CITY OF KELOWNA

MEMORANDUM

Date: August 8, 2019
File No.: Z19-0108
To: Urban Planning (SS)
From: Development Engineer Manager (JK)
Subject: (Wof) Hwy 97N, Lot 1, plan EPP76079, Sec. 2, Twp. 23, ODYD.

The Development Engineering comments and requirements regarding this Rezoning application to rezone the property from A1 – Agriculture to I1 Business Industrial for the subject property are:

Figure 4 - Industrial (I1) Site Plan

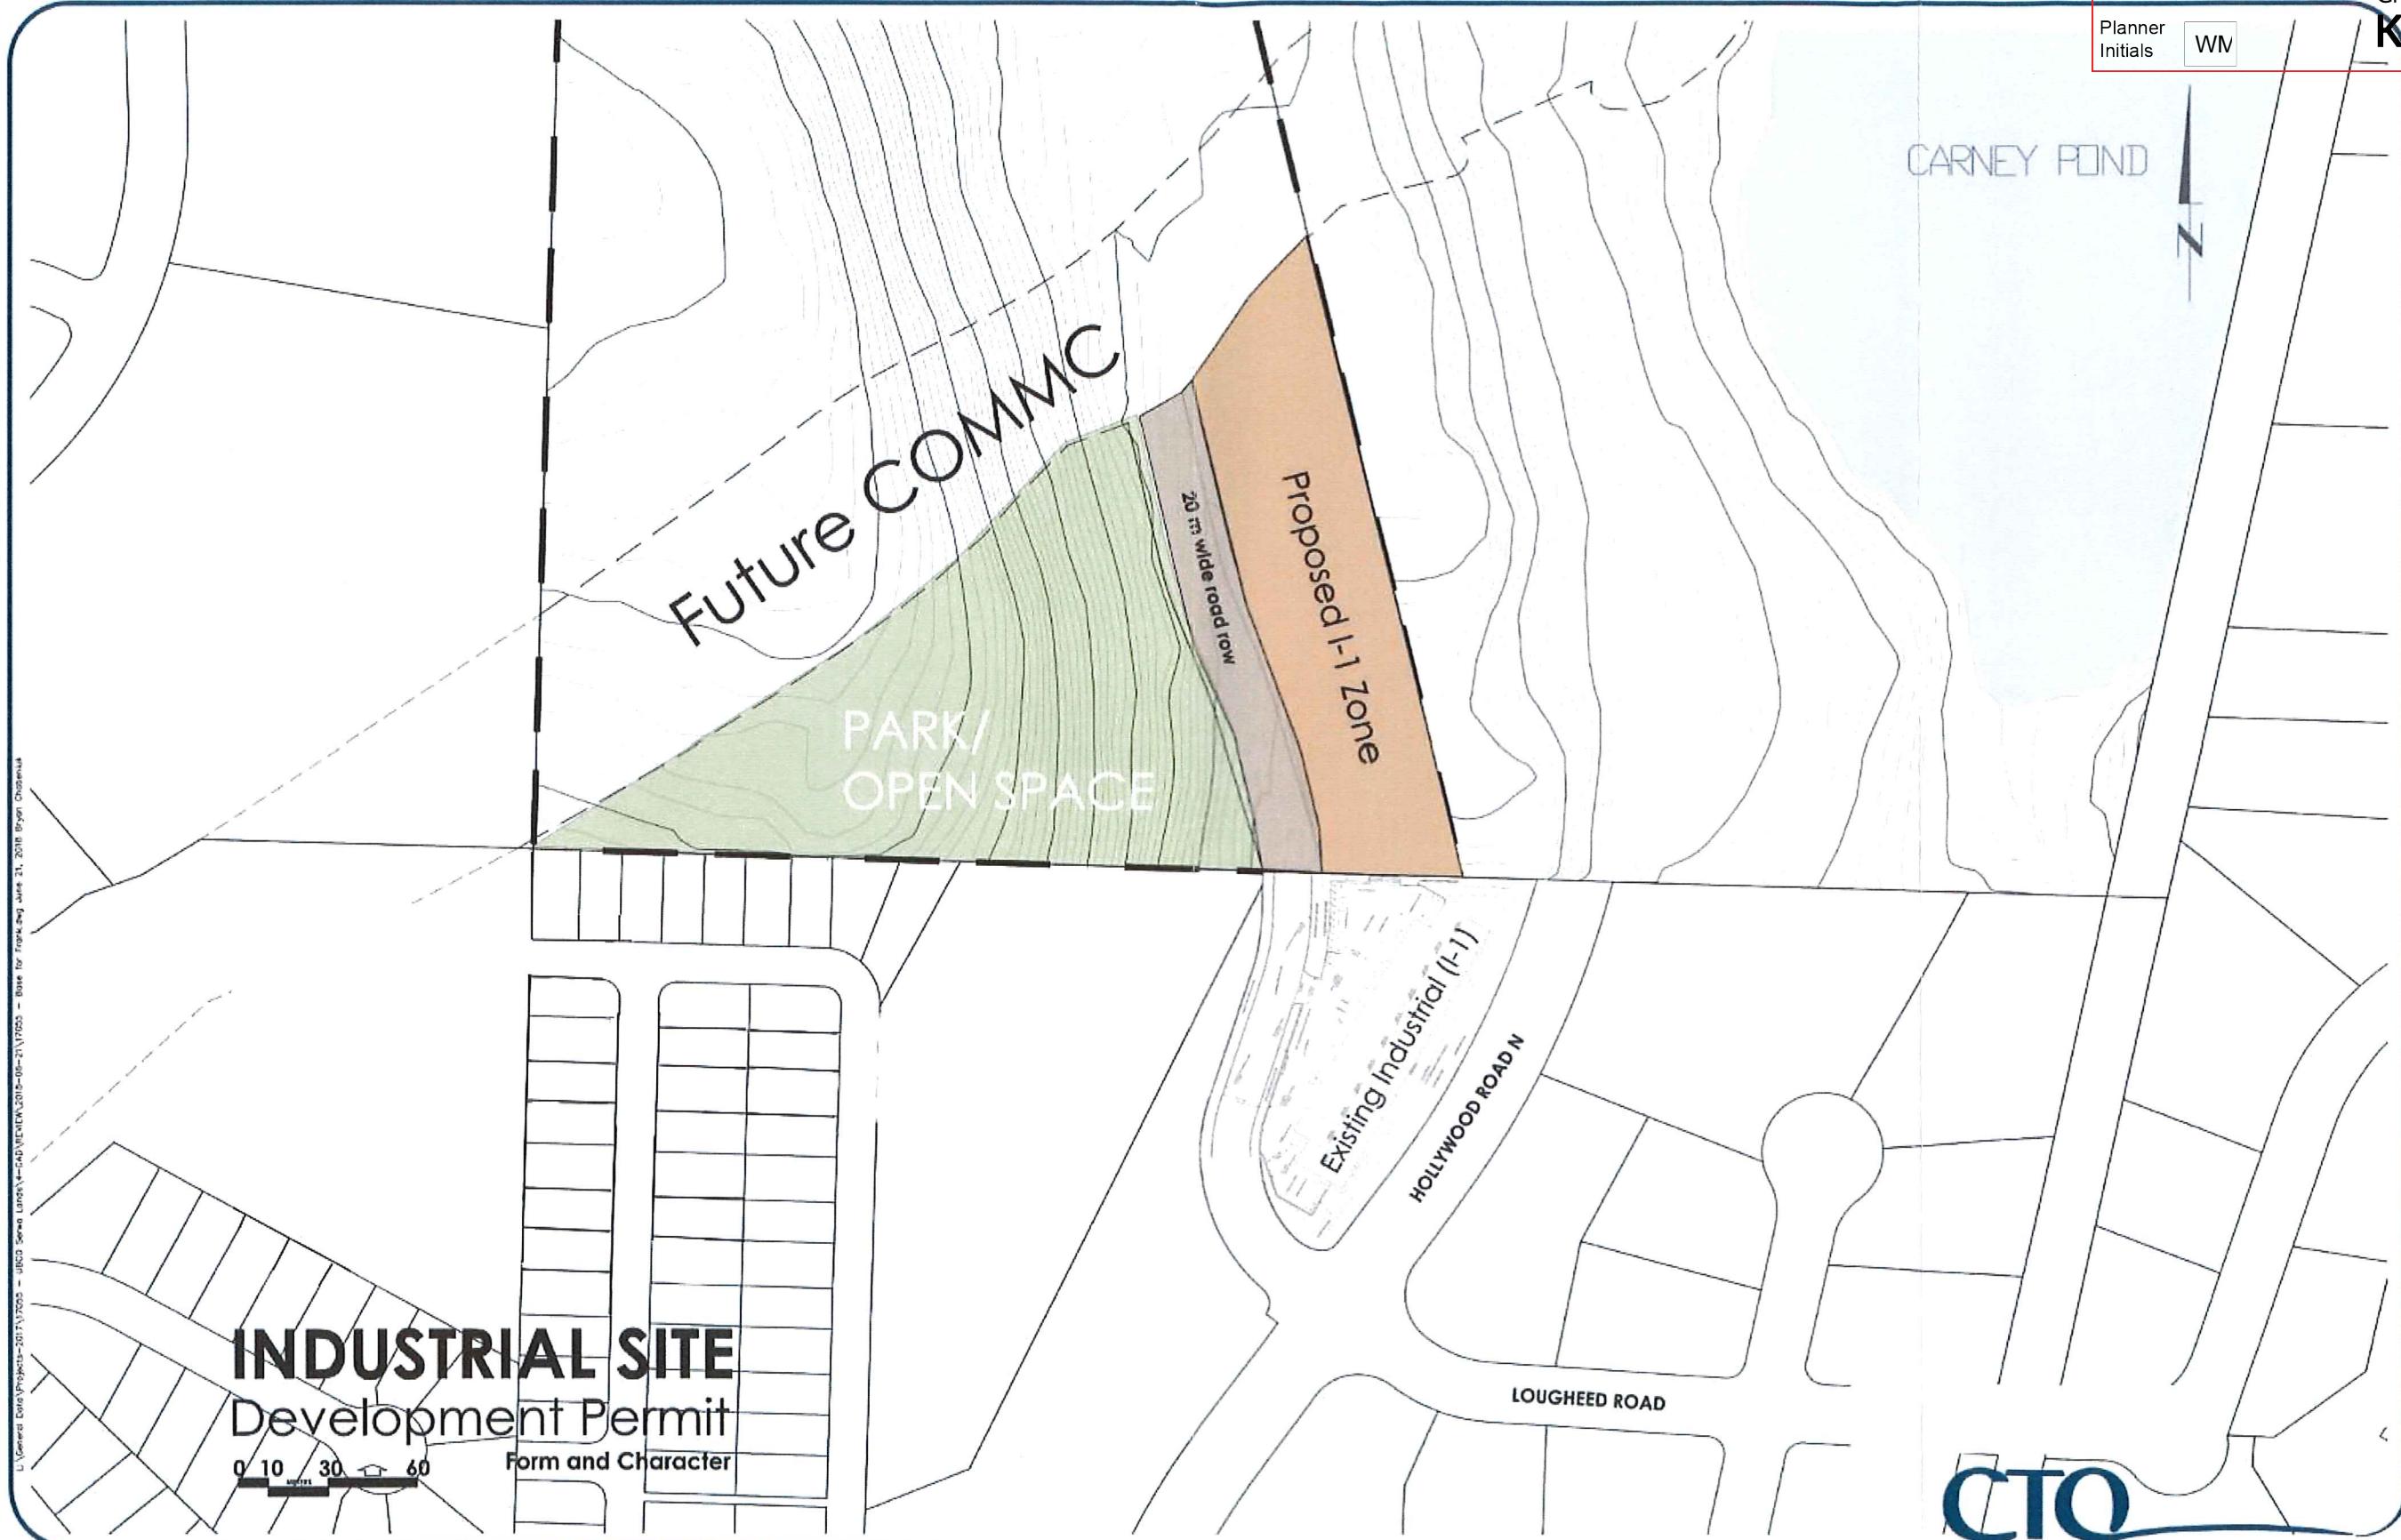
- d) Only access to development will be allowed from Loughheed Road.
- e) All Offsite construction work must be approved by Development Engineering group at City of Kelowna.

- a) Provide all necessary Statutory Rights-of-Way for any utility corridors required, including those on proposed or existing City Lands.
- b) If any road dedication affects lands encumbered by a Utility right-of-way (such as Fortis, etc.) please obtain the approval of the utility prior to application for final subdivision approval. Any works required by the utility as a consequence of the road dedication must be incorporated in the construction drawings submitted to the City's Development Manager.
- c) An MSU standard size vehicle must be able to manoeuvre onto and off the site without requiring a reverse movement onto public roadways.
- d) Indicate on the site, the locations of loading bays as well as the garbage and recycle bins.
